PROFILE- STEELE STREET

DESIGNED G. GAENZ	NESTE, BRUDIN & STONE CIVIL ENGINEERS 157 W. Fifth St. San Bernardino, Calif. Date Calif. Reg. No. 8613	APPROVED July 19 1966 City Engineer R.C.E. No. 13,653	DEPARTMENT OF ENGINEERING CITY OF SAN BERNARDINO
DRAWN A. CABRAL		DRAWING NO 3472	DRAWN BY A. Cabral
CHECKED R.J.A.N.		SHEET 2 OF 2 SHEETS	CHECKED BY
JOB No. 59-66.01			RECOMMENDED BY
SCALE: As Shown			TRACT 7754 STEELE STREET

PLAN-DRAINAGE STRUCTURES

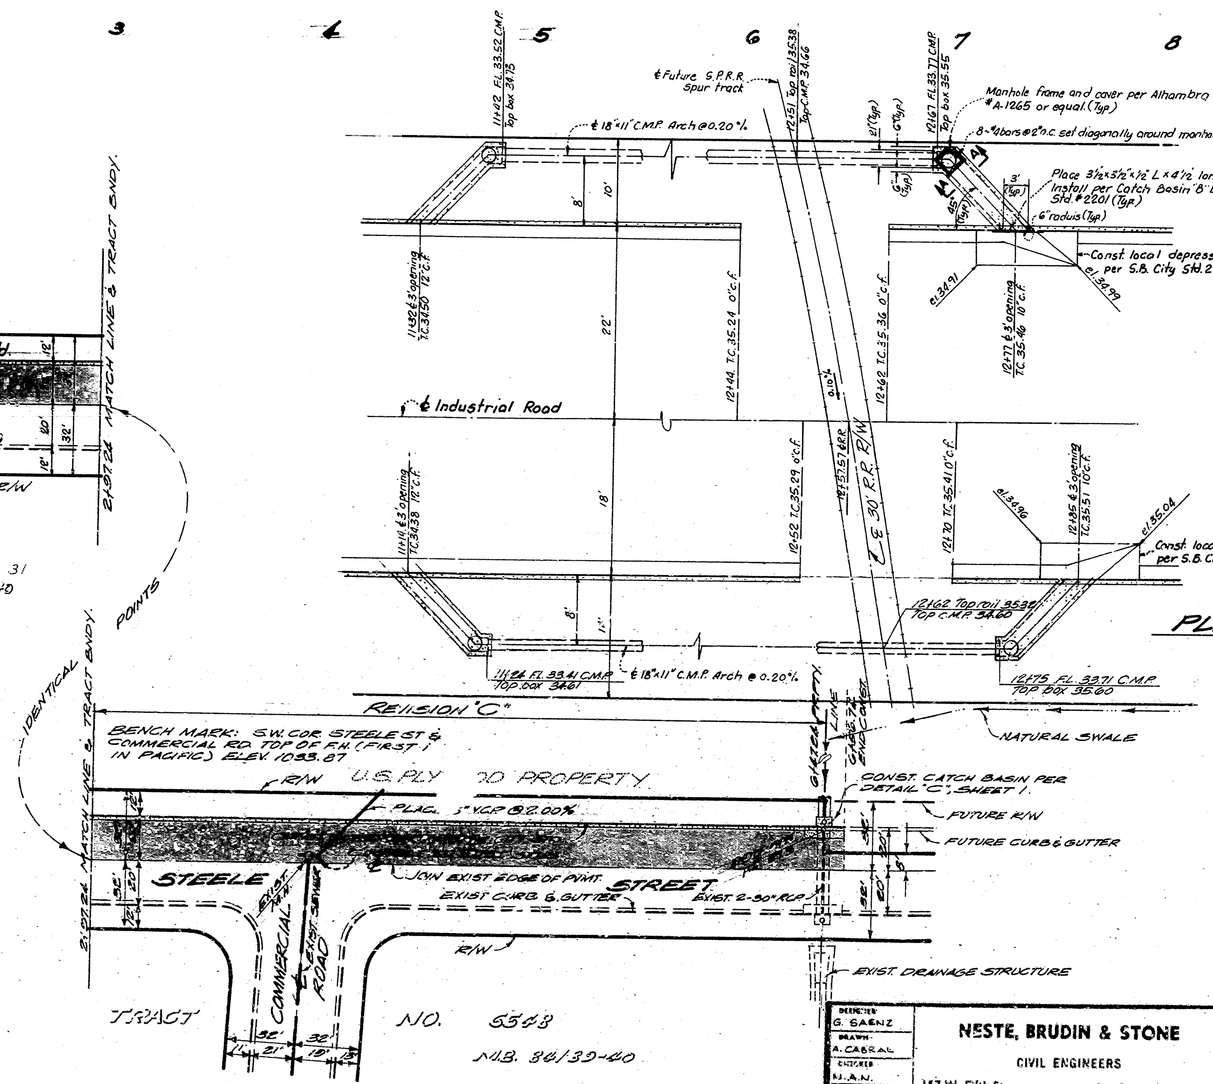
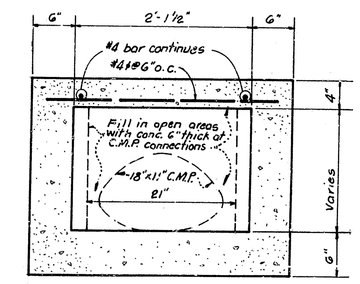
Revision, Tr. No. 7754 - Change in Gage of 18"x11" C.M.P. Arch — Date 12-7-66
Approved: City Engineer — R.C.E. 13653 — Date 12-8-66
REVISION "C", ADOPTION OF U.S. PLYWOOD PCL. DATE 11-16-66
APPROVED: CITY ENGINEER R.C.E. 13653 DATE 1-19-67

NOTE: 18"x11" C.M.P. Arch shall be 12 Ga. within the 30' R.R. R/W- both sides of street. Remaining portion to be 14 Ga.

PLAN-DRAINAGE STRUCTURES

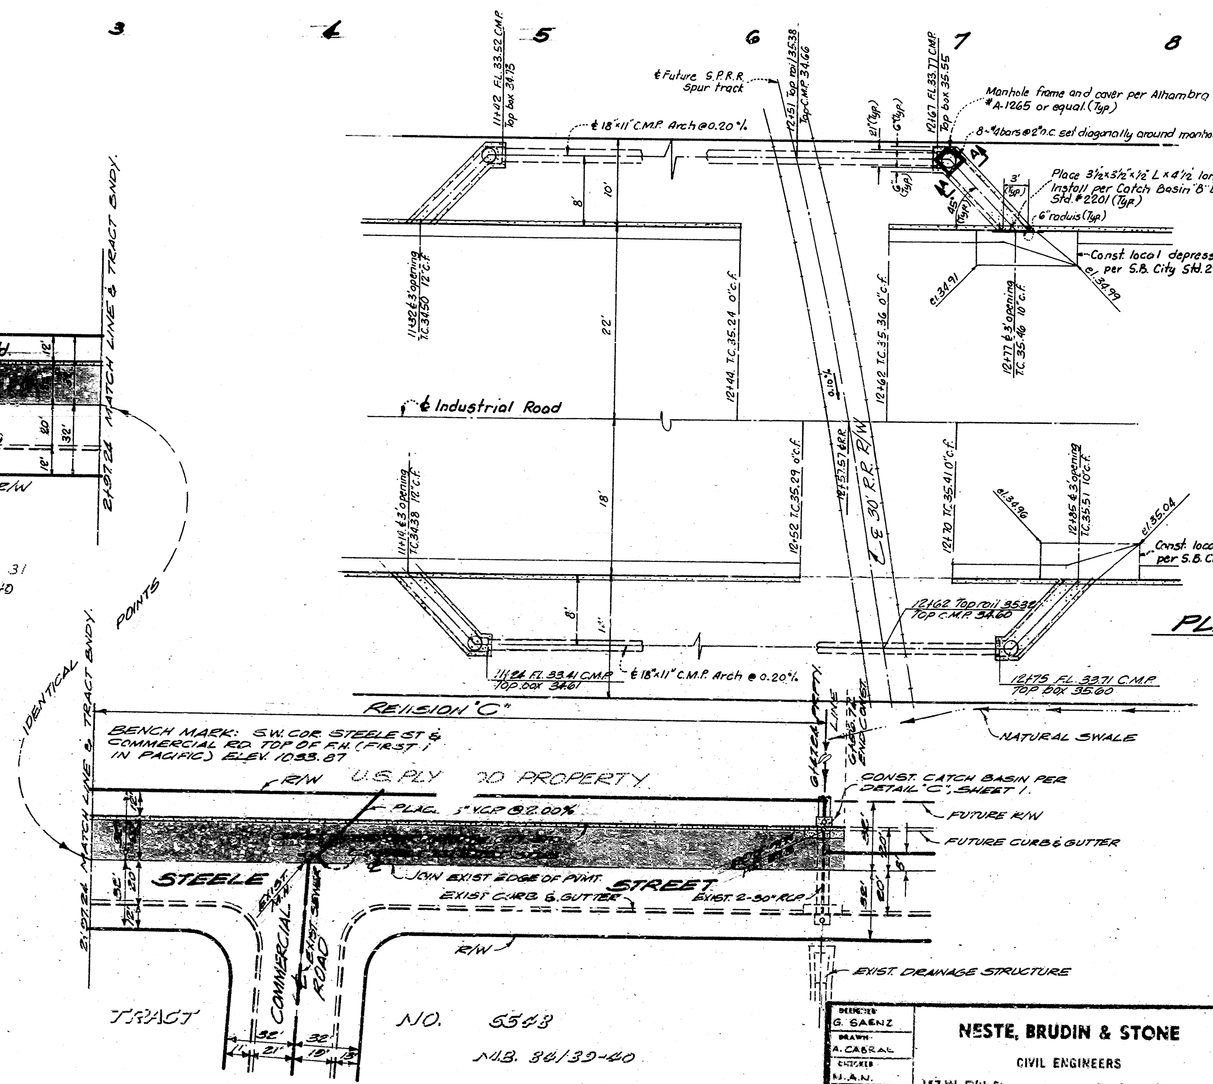
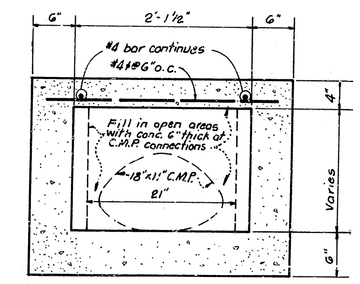
Revision, Tr. No. 7754 - Change in Gage of 18"x11" C.M.P. Arch — Date 12-7-66
Approved: City Engineer — R.C.E. 13653 — Date 12-8-66
REVISION "C", ADOPTION OF U.S. PLYWOOD PCL. DATE 11-16-66
APPROVED: CITY ENGINEER R.C.E. 13653 DATE 1-19-67

NOTE: 18"x11" C.M.P. Arch shall be 12 Ga. within the 30' R.R. R/W- both sides of street. Remaining portion to be 14 Ga.
